Diesel Exhaust Fluid (DEF) Tank Harness
Bracket and Routing

CHU, CXU, GU, TD

FSB 258-031, DEF Tank Harness Bracket and Routing

W3071686

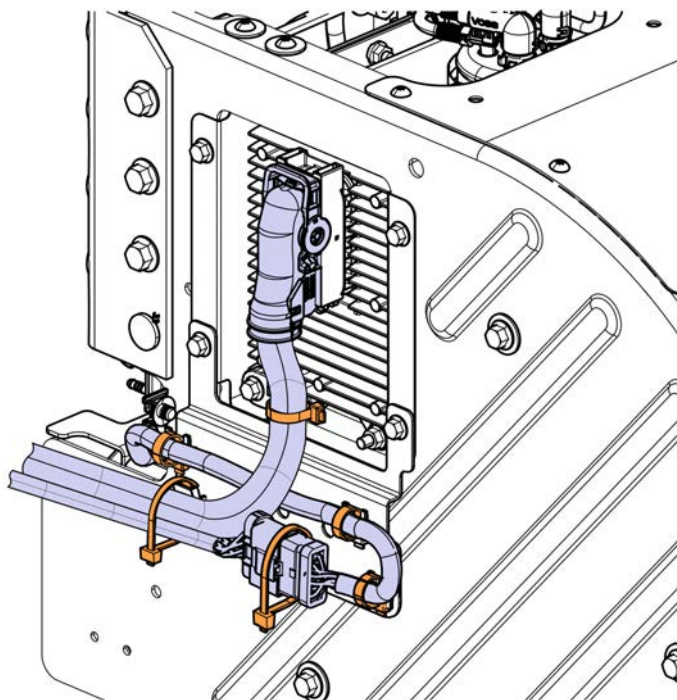
On certain Mack vehicles built before February 13, 2012, the front chassis to urea tank connection, located on the side of the def tank, may rub the mounting bracket or not stay secured to the mounting bracket. This can lead to electrical faults or corrosion of the connections. Use the following procedure to relocate and to provide a better mounting of the connector and harness.

W3071685

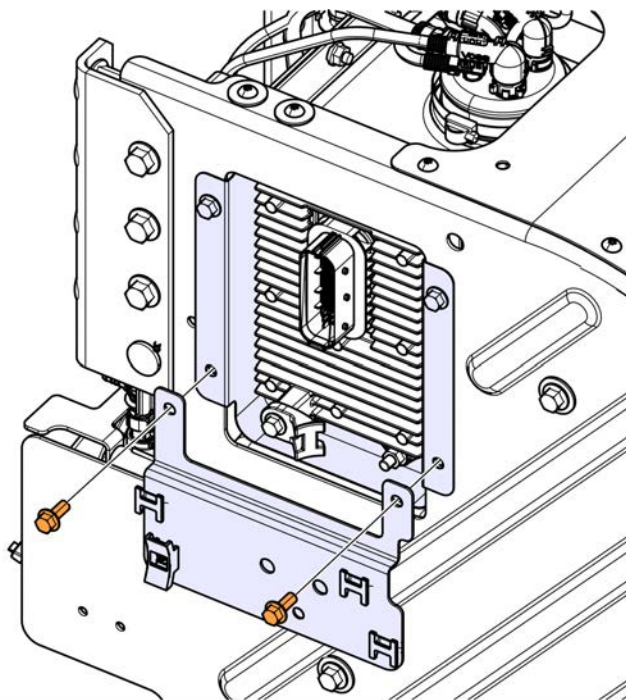
- 1 Remove all cables from ground (negative) battery terminals to prevent personal injury from electrical shock and prevent damage to electrical components
- 2 Cut cable ties as needed to loosen the DEF harness and connector
- 3 Remove the two lower fasteners which secure the After Treatment Control Module (ACM) and the "L" bracket to the DEF tank. Discard the L bracket.
- 4 Install the new bracket into position on the DEF tank. Secure fasteners and tighten to 24 ± 4 Nm (18 ± 3 ft-lb)

W3071684

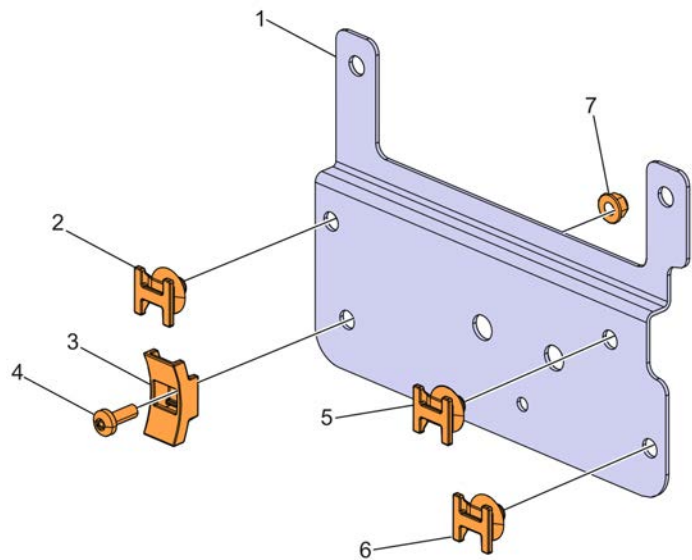
5 Install the fasteners (3 push-in retainers, 1 saddle retainer) onto the new mounting plate

W3071686

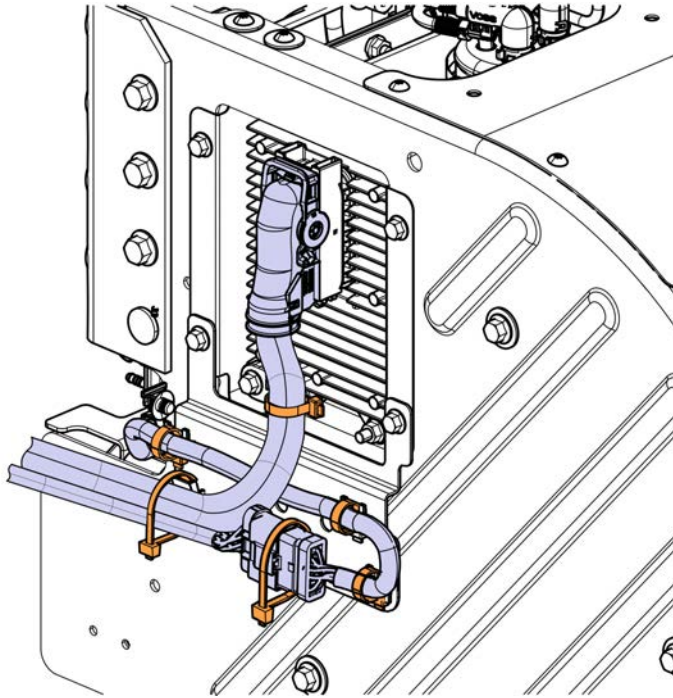
- 6 Route and secure the DEF harness to the bracket with cable ties as shown in illustration.
Route the connector cable tie through existing holes in the bracket.
- 7 Route and secure the ACM breakout to bracket with cable ties as shown in illustration

Note: Ensure that the harness and connectors are retained and do not make contact with the bracket causing rubbing.
